Change Orders Nos. 1 – 13, 15-20, & 22-24: Contract No. C003SPRC15

RE: C003SPRC15 (GEC)
Design/Build for Paul E. Joseph Stadium & Sports Complex, St. Croix, VI

RE: Justification for Change Order 1
Design-Build of Paul E. Joseph Stadium and Sports Complex
Contract No. C003SPRC15

Figure 2: Locations for the proposed Phase II Testing and Evaluation Studies in the PEJ.

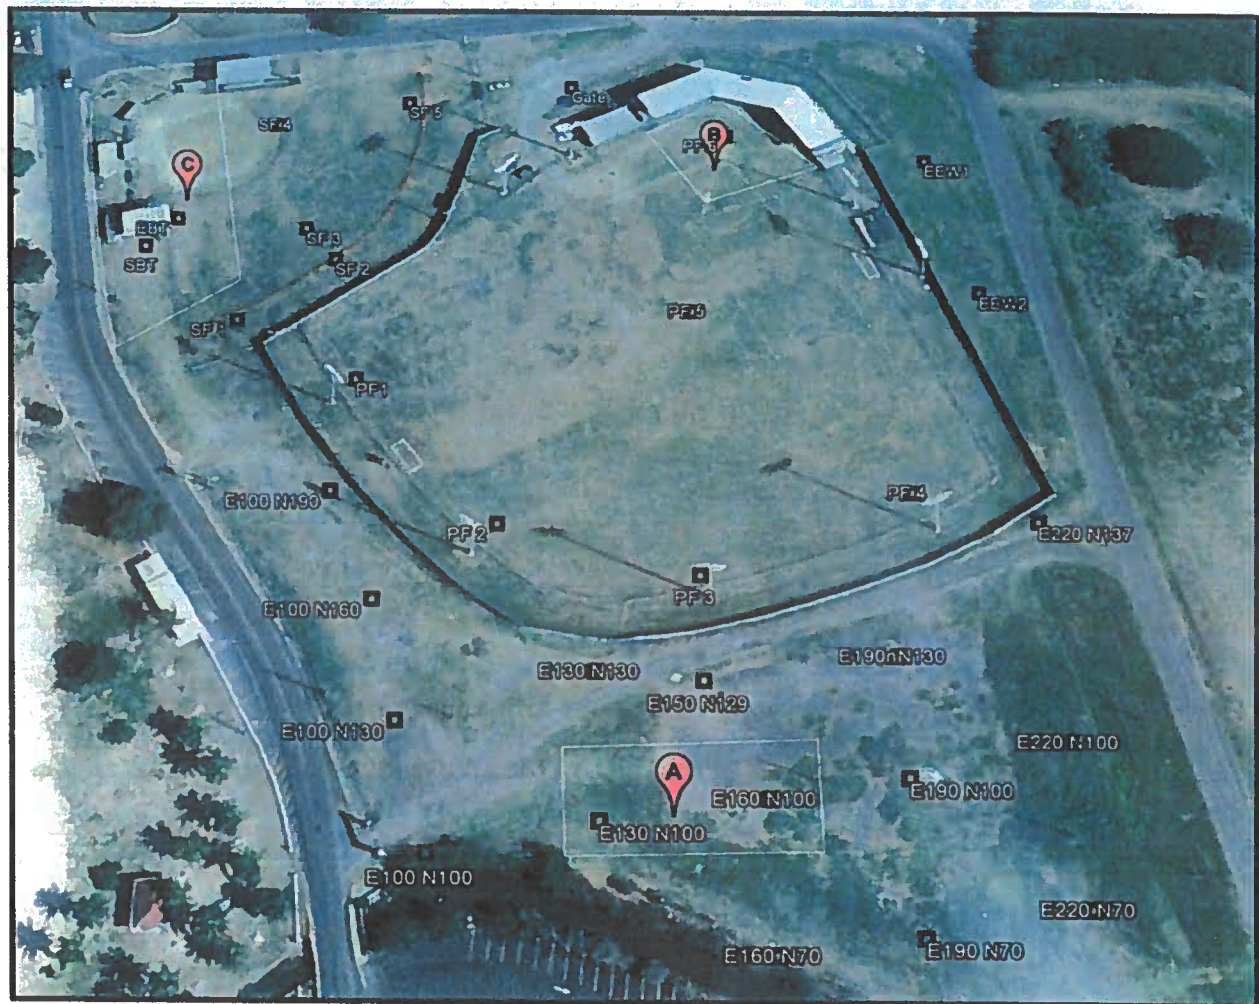
The fieldwork for Stage II will consist of excavations of test units in three areas of concern for the PEJ including Areas A, B, and C, as shown in Figure 2 below. Phase II testing is also proposed for the MAC (Figure 3).

The archaeological contexts identified in Soltec's test trenches (East and South Bleacher) are composed of materials ordinarily associated with historic domestic contexts. The deposits were found to be contained in the upper 50 cm of the soil column. OAR proposes to define the limits of the midden deposit through close order shovel testing at 10 m intervals followed by the excavation of at least two, 1 by 1 m test units to evaluate the contextual integrity of the deposits and their research potential.

Figure 3: Proposed MAC project area.

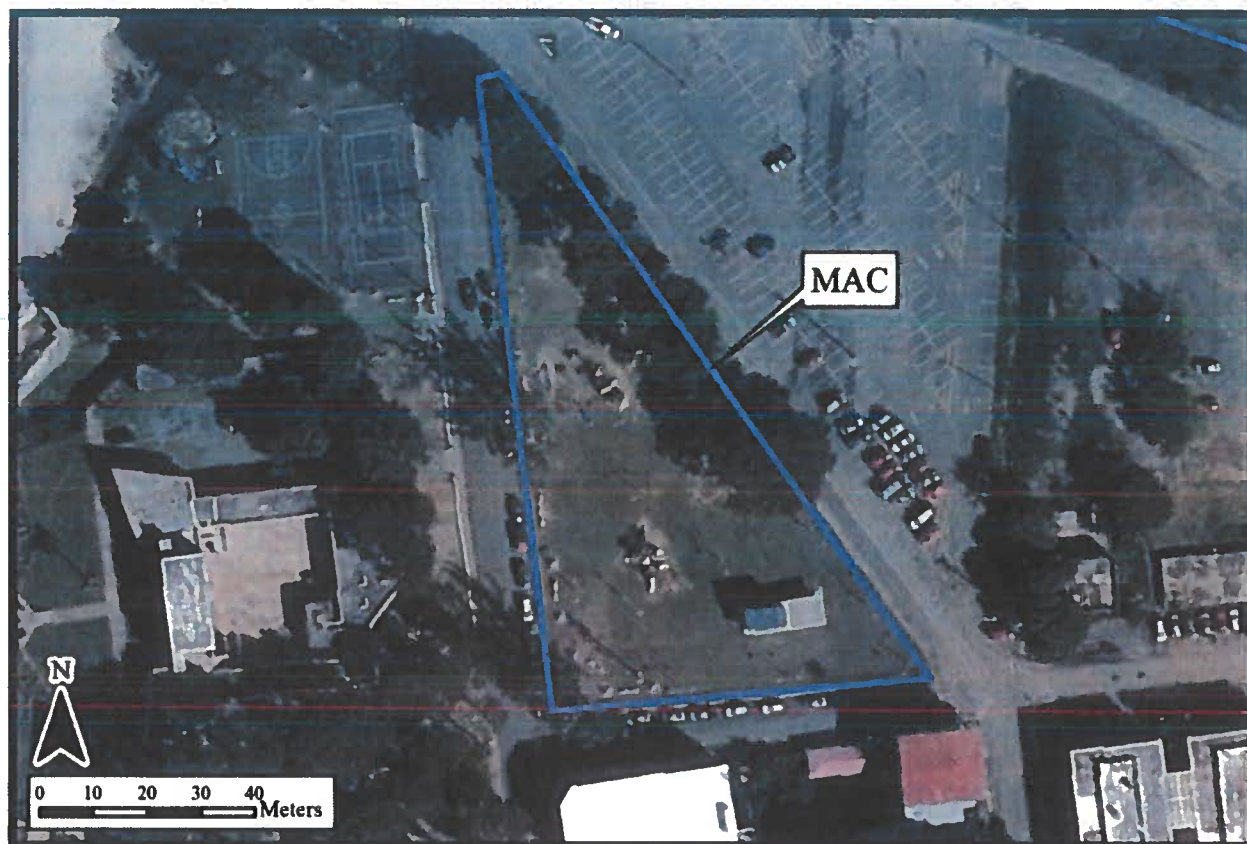
The MAC (Figure 3) was found to contain materials dating primarily to the 18th and 19th centuries. The southeast corner of the MAC was found to contain deep deposits (>1 m), while the rest of the MAC was found to contain deposits in the upper 40 cm of soil. OAR proposes to test the MAC using a combination of shovel tests and formal test units. The MAC will be shovel tested at 5 m intervals to gain an initial understanding of the general distribution of cultural materials and their contexts. Using the results of the shovel testing, OAR will select three areas to test using 1 m by 1 m test units. Additionally, one, 1 m by 2 m test unit will be excavated to test the deeper deposits in the southeast corner of the MAC.
